Access Compliance Report

Public Rights-of-Way

(Curb Ramps)

Intersection ID: N/A	Main Street: CLARKSON_ST	Cross Street: POST_ST	Location:	N
ADA ID: FD39B6F0A578	Ramp Type: Perp	Initial Pass/Fail: Fail	Overall Compliance: No	Severity Score: 1.25
Codes/Mitigation Info/Possible Solution		Field Measurements/Component Compliance

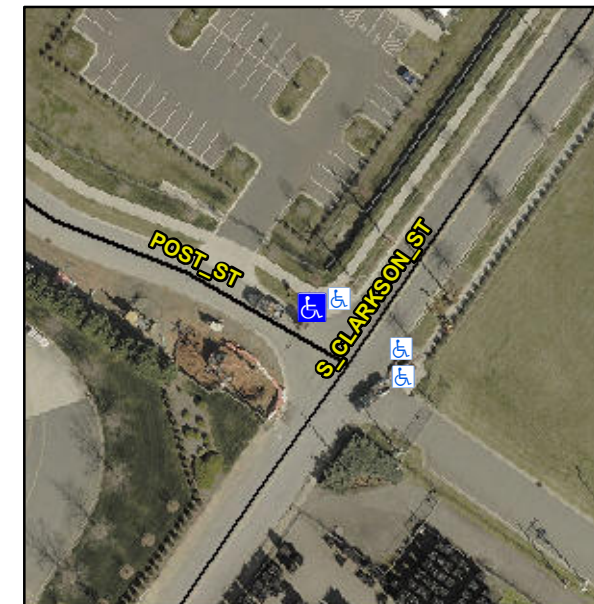
Not Found, R304.5.3

Compliance	Description	Data	Compliance	Description	Data
N/A	Ramp Length (in)	97.0	Yes	Ramp Slope (%)	5.4
Yes	Ramp Width (in)	48.0	No	Ramp XSlope (%)	2.2
N/A	Flare Type LT	N/A	N/A	Flare Type RT	N/A
N/A	Flare Slope LT (%)	N/A	N/A	Flare Slope RT (%)	N/A
N/A	Flare Traversable LT?	N/A	N/A	Flare Traversable RT?	N/A
N/A	Landing Length (in)	N/A	N/A	DWS Provided?	N/A
N/A	Landing Width (in)	N/A	N/A	DWS Contrast?	N/A
N/A	Landing Slope (%)	N/A	N/A	DWS Length (in)	N/A
N/A	Landing X Slope (%)	N/A	N/A	DWS Full Width?	N/A
N/A	Landing Curb? (Y/N)	N/A	N/A	DWS Offset (in)	N/A
N/A	Shared Landing?	N/A			
N/A	Gutter Ponding?	N/A	N/A	Gutter Slope (%)	N/A
N/A	Gutter Lip Ht (in)	N/A	N/A	Gutter X Slope (%)	N/A
N/A	Painted X Walk1?	No	N/A	Painted X Walk2?	N/A
	X Walk 1 Direction	To SW		X Walk 2 Direction	N/A
N/A	X Walk 1 Width (in)	N/A	N/A	X Walk 2 Width (in)	N/A
	X Walk 1 Slope (%)	3.2		X Walk 2 Slope (%)	N/A
	X Walk 1 X Slope (%)	3.4		X Walk 2 X Slope (%)	N/A

Remove & Replace Entire Ramp.
